Environment Impact Assessment NPP Cernavoda 1 and Interim Waste Storage (Romania)

***Refurbishment of npp Cernavoda 1 and Extension
of Intermediate Dry Spent Fuel Storage with
MACSTOR-400 Modules***

Environment Impact Assessment

REPORT
REP-0930

Figure 1:
FlexRISK: example of the
effective adult dose
1 year

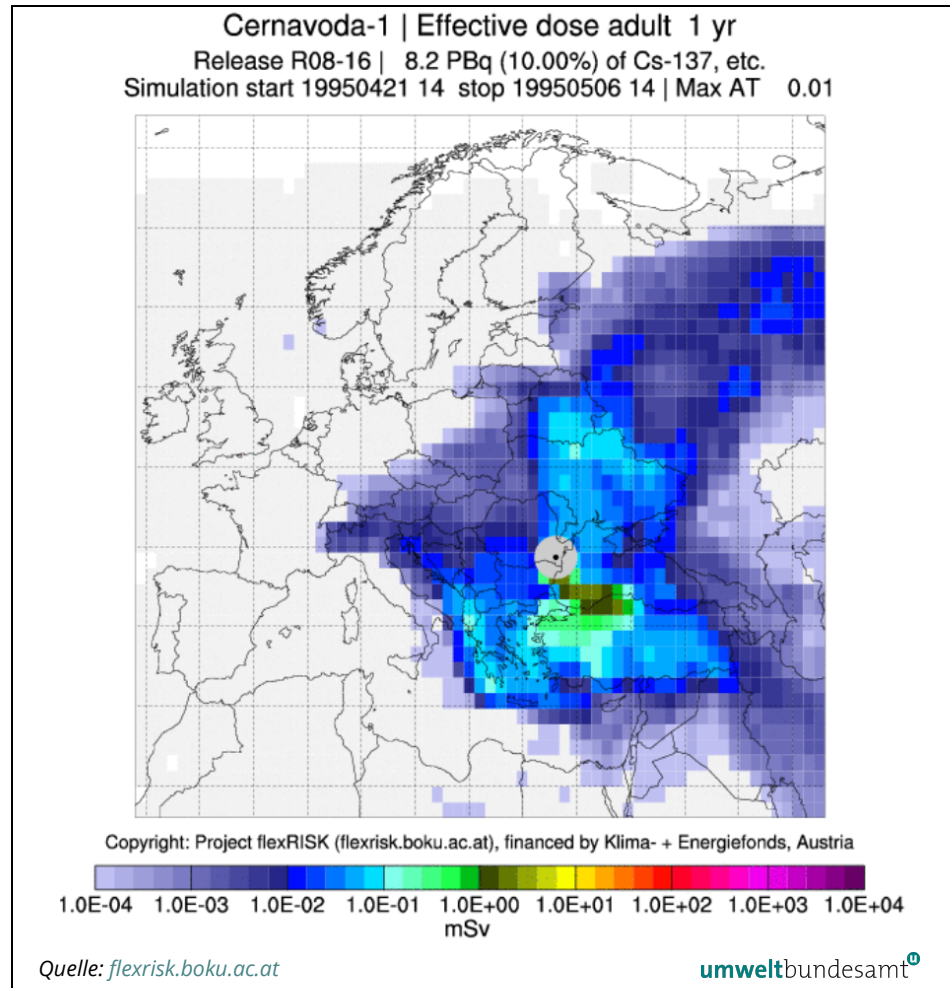
The only results of an accident analysis presented in a transboundary context are those of the “Feeder Stagnation Break” DBA, which is considered in the last revision of the FSAR of Cernavoda U1 as having the most serious consequences. The maximum value of the individual effective dose following the exposure to the postulated release for a period of 30 days is 5.5 mSv, at 1 km distance from the reactor. At 30 km distance, this value drops to 16 μSv ; at 100 km distance, the values are 1 – 3 μSv .

While this is not surprising – the maximum 1-y effective dose for an adult in Austria estimated by FlexRISK is 10 μSv – severe accidents and accidents affecting more than one nuclear installation at the site could result in higher doses.
